**Before the Hearings Panel
At Waimakariri District Council**

In the matter of the Proposed Waimakariri District Plan

**Council reply on Rangawaka-Transport (TRAN) – Andrew MacLennan on
behalf of Waimakariri District Council**

Date: 30 November 2023

Figure TRAN-4: Accessway visibility splay to achieve minimum sight lines for pedestrian safety

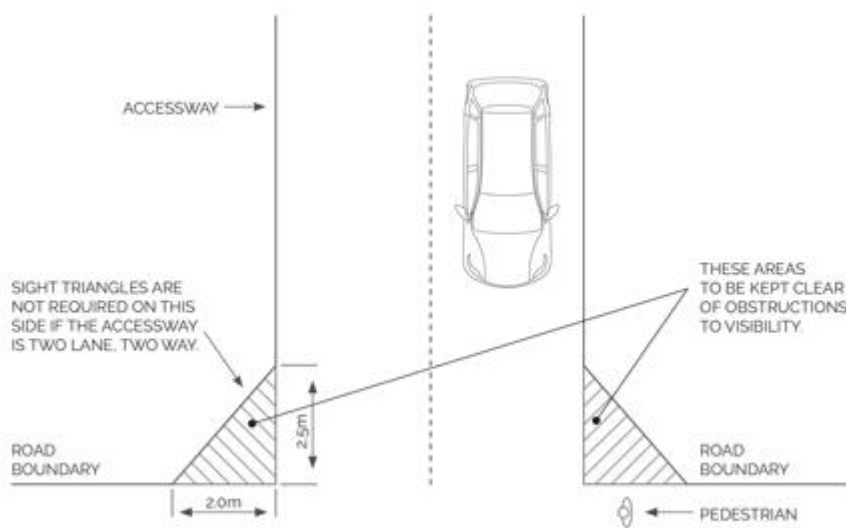
⁵³ George Jason Smith [270.15]

2. Access can be provided by two separate one-way crossings each with a minimum width of 3.5m.
3. ~~Where any new vehicle accessway in Residential Zones or Rural Zones will serve six or more sites; or where vehicle movements on any new accessway will exceed 100 per day exceed the above thresholds, see TRAN-R6.~~^{54 55}
4. Where a footpath is required, this can be provided within the minimum legal width but is additional to the minimum formed width.⁵⁶

Figure 1: Approach Sight Triangles for Level Crossings with “Stop” or “Give Way” Signs

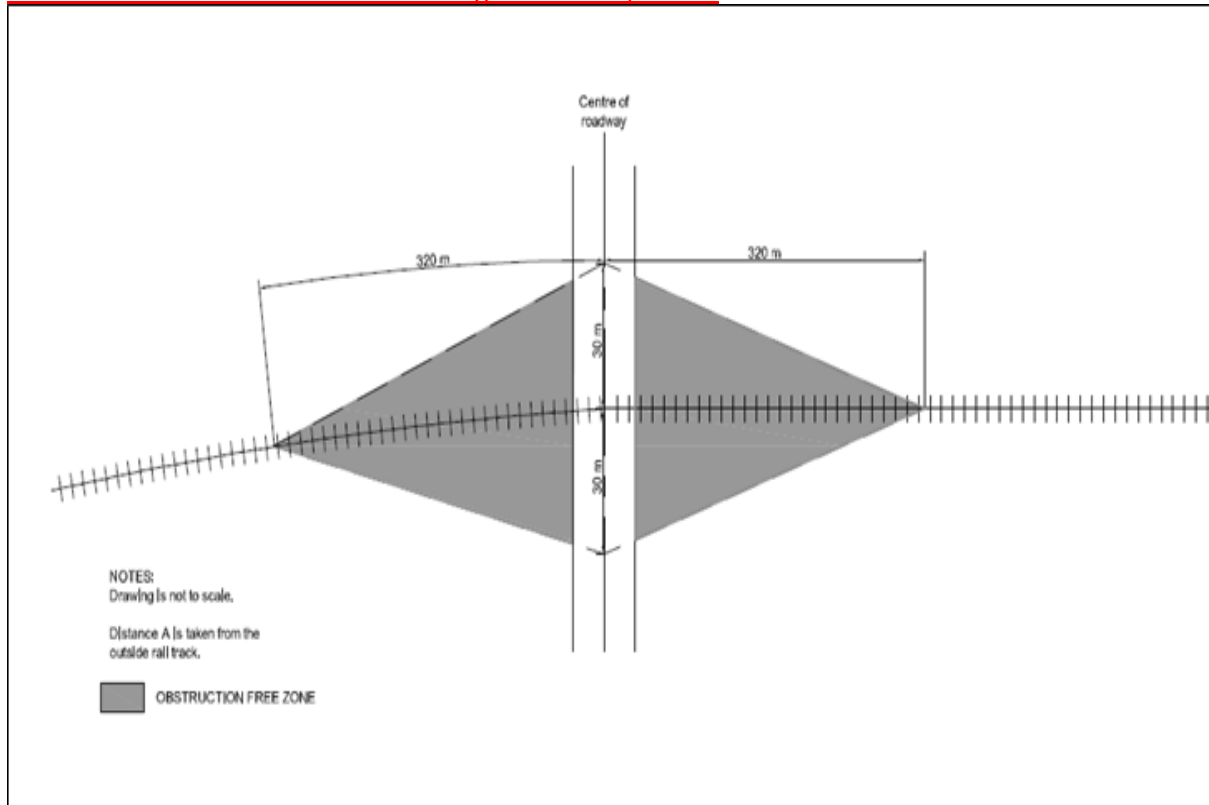
⁷⁹ KiwiRail Holdings Ltd [373.40] [373.41]

On sites adjacent to rail level crossings controlled by Stop or Give Way Signs, no building, structure, road intersections, vehicle crossings or vegetation shall be located within the shaded areas shown in Figure 1. These are defined by a sight triangle taken 30 metres from the outside rail and 320 metres along the railway track.
